MEMO

To: Planning Commission
From: Hector Soto, Jr., AICP, Senior Planner
CC: File
Date: September 21, 2023
Re: Appl. #PL2023-151 - PRELIMINARY DEVELOPMENT PLAN – Streets of West Pryor, Lots 11 and 13;
Streets of West Pryor, LLC, applicant

Figure 2 - Revised site plan.

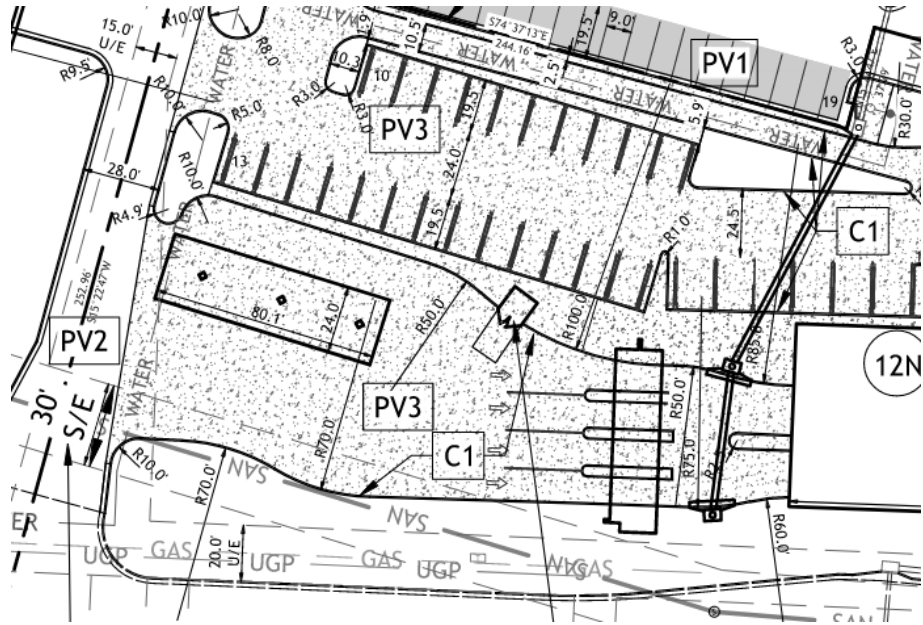
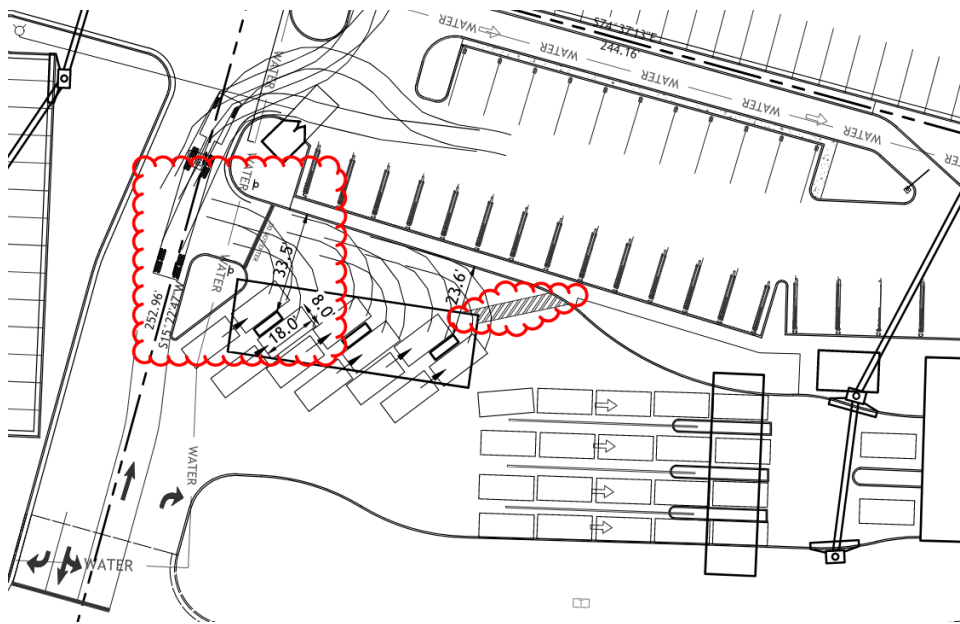
Following the applicant's and staff's presentations during the public hearing held on August 24, 2023, the Planning Commission expressed concerns regarding circulation conflicts in and around the entrance area of Lot 11, which is the site of the proposed tunnel carwash facility. The facility entrance area houses the queue to the tunnel carwash and a double-sided 3-pump fueling station. Primary concerns included: the conflict between gas-only customers leaving the site and customers entering the site through the same curb cut; adequate turning radius for gas-only customers to negotiate turning movements exiting the site without conflicting with the tunnel queue; and the lack of a defined pedestrian path between the pump islands and the customer service area inside the carwash tunnel building. The Planning Commission continued the public hearing to allow the applicant the opportunity to address the concerns.

To address concerns on the original site plan regarding gas-only customers exiting the site conflicting with customers entering the site through the same driveway, a median break has been provided off the northwest corner of the pump island area to provide a dedicated exit for gas-only customers that is separate from the site entrance. Signage and pavement markings are provided to denote the drive as exit only. The new exit aisle complies with the minimum width for a one-way travel lane. The reconfigured

To address concerns on the original site plan regarding adequate turn radius for gas-only customers in order to negotiate their exit without conflicting with the carwash tunnel queue, the pump island area has been angled to facilitate turning movements in the direction of the newly added dedicated exit. Turning templates for a large SUV have been added to each pump to demonstrate adequate turning radii. Dimensions have also been added to the two exterior pumps to denote the adjacent exit aisle width. The exit aisle has 23.6' of clearance from the easternmost pump to the adjacent curb, and 33.5' of clearance from the westernmost pump to the adjacent curb.

To address concerns on the original site plan regarding a lack of dedicated pedestrian path between the pump island area and the customer service area inside the carwash tunnel building, a striped crosswalk leading to a new sidewalk has been provided.

fueling station area also complies with the minimum queue space requirements without conflicting with the adjacent drive aisle that provides access to adjacent pad sites to the north and west.
